REMARKS

Applicant graciously appreciates the Office's attention to the instant application. In view of the following remarks, Applicant respectfully requests reconsideration and allowance of the subject application. This amendment is
5 believed to be fully responsive to all issues raised in the July 20, 2004 Office Action.

FIG. 12

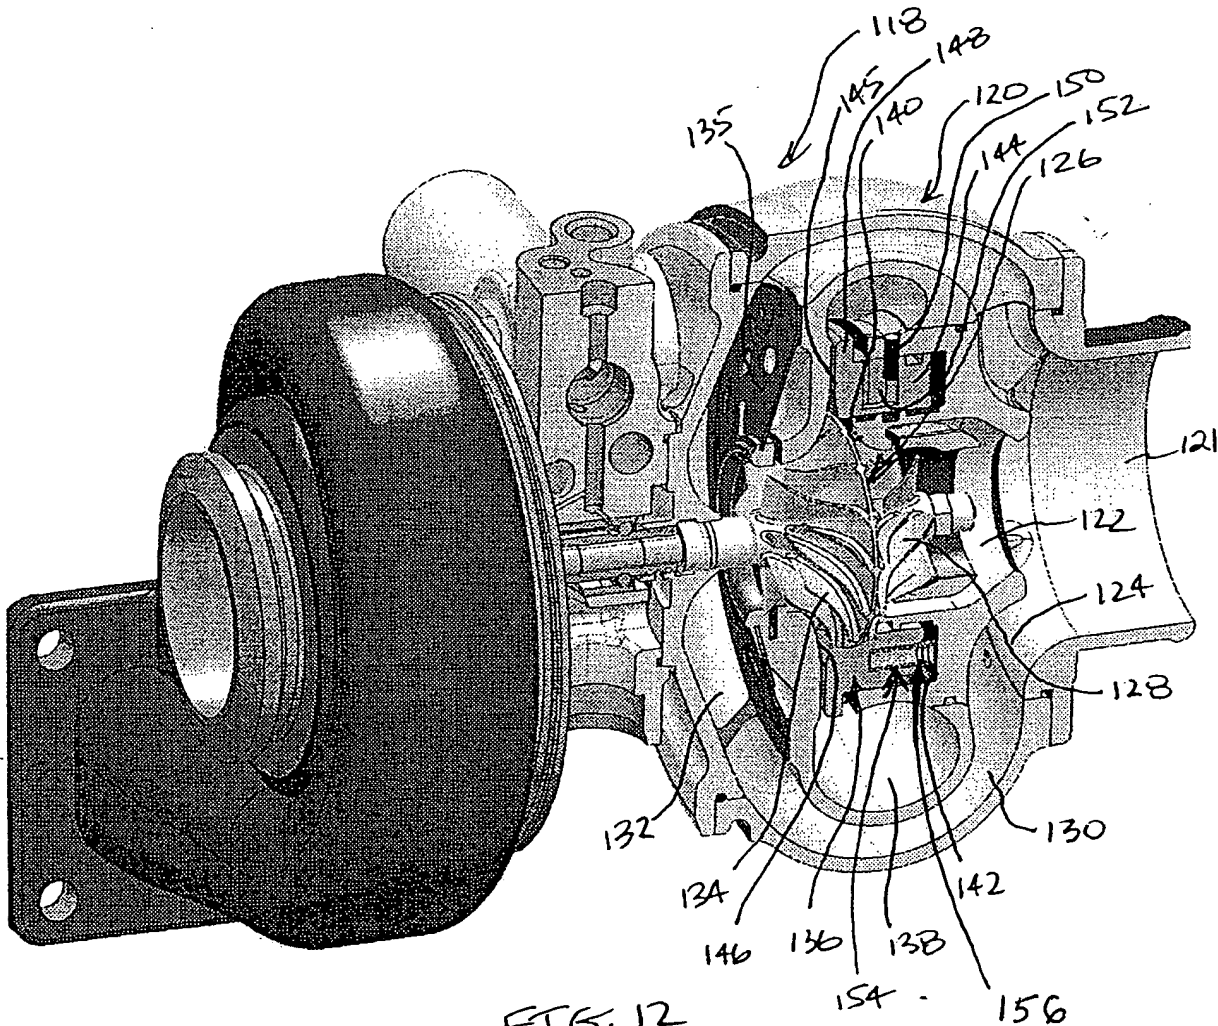
Applicant has amended Figs. 12 and 13 per suggestions by the Office. Applicant notes that a label for "slot 170" did appear in Fig. 13 for the means in an "unactuated" position (upper portion of figure). To clarify, Applicant has
20 added a label for the means in an "actuated" position (lower portion of figure).

The attached sheets of drawings includes changes to Fig. 12 and to Fig. 13. These sheets replace the original sheets for Fig. 12 and for Fig. 13, respectively. In Fig. 12, previously omitted element "one or more springs 156" has been added. In Fig. 13 the element "a slot 170" appeared in the upper portion of figure for the "unactuated position" but did not appear in the "actuated position" in the lower portion of the figure. Thus, a label to the slot 170 has been added to the lower portion of the figure.
